VSP-75

VENDOR SERVICE PUBLICATION

SUBJECT: Avco Lycoming Service Letter No. L218 and Service Instruction
No. 1059C, No. 1110C and No. 1257E

Typical Adapter Installation

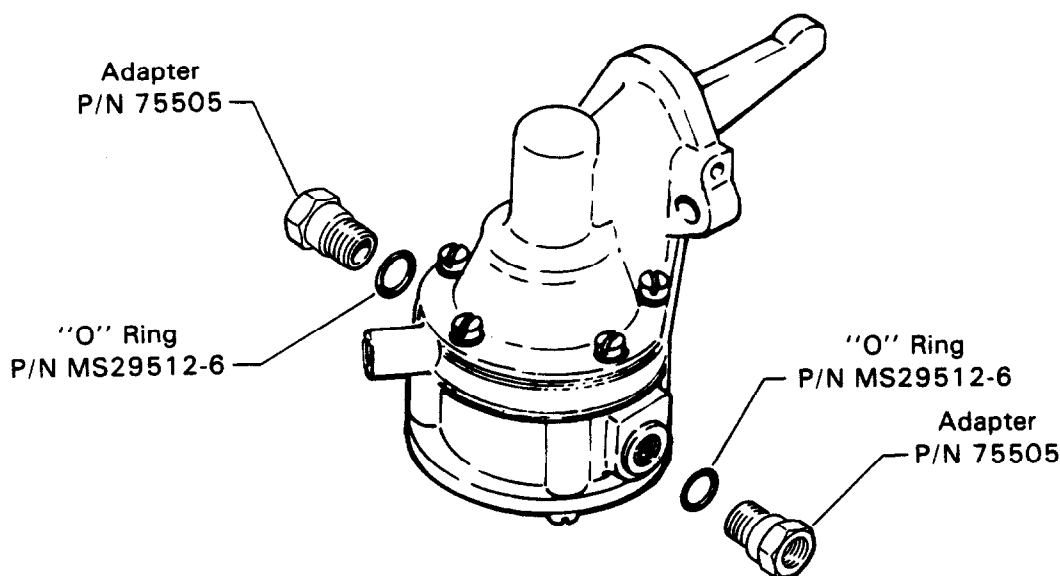
When replacing certain older AC diaphragm type fuel pumps, AC P/N 40174 or P/N 56999 (tapered pipe thread inlet and outlet ports) with a new pump incorporating straight thread ports, an adapter P/N 75505 is available to adapt the pipe thread fittings to the new pump. All newer types of fuel pumps incorporate straight thread ports.

When the older model fuel pumps are replaced with new models, 2 Adapters P/N 75505 and 2 "O" Rings P/N MS29512-6 (one for each adapter) must be ordered separately for proper installation.

Figure 1.
Carburetor Showing Area to be Machined

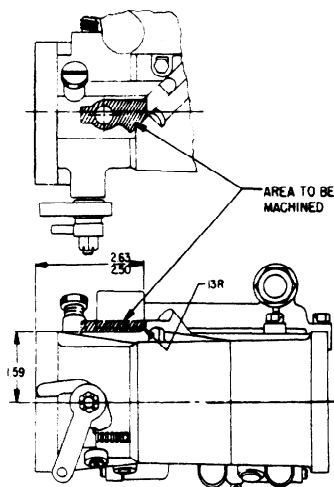
Because of the increased size of the new AC fuel pumps, certain engine models using P/N LW-16335 fuel pump with rear mounted carburetors must have the carburetor reworked to remove the back suction economizer boss. (If not already accomplished or prior to installation of new P/N LW-16335 fuel pump.) See Table 1. Using suitable equipment machine this boss as shown in Figure 1. Also, because of the increased size of the new fuel pump, certain dual magneto engine models must have the accessory housing reworked. See Table 2. Again, using suitable equipment, machine the boss on the accessory housing as shown in Figure 2.
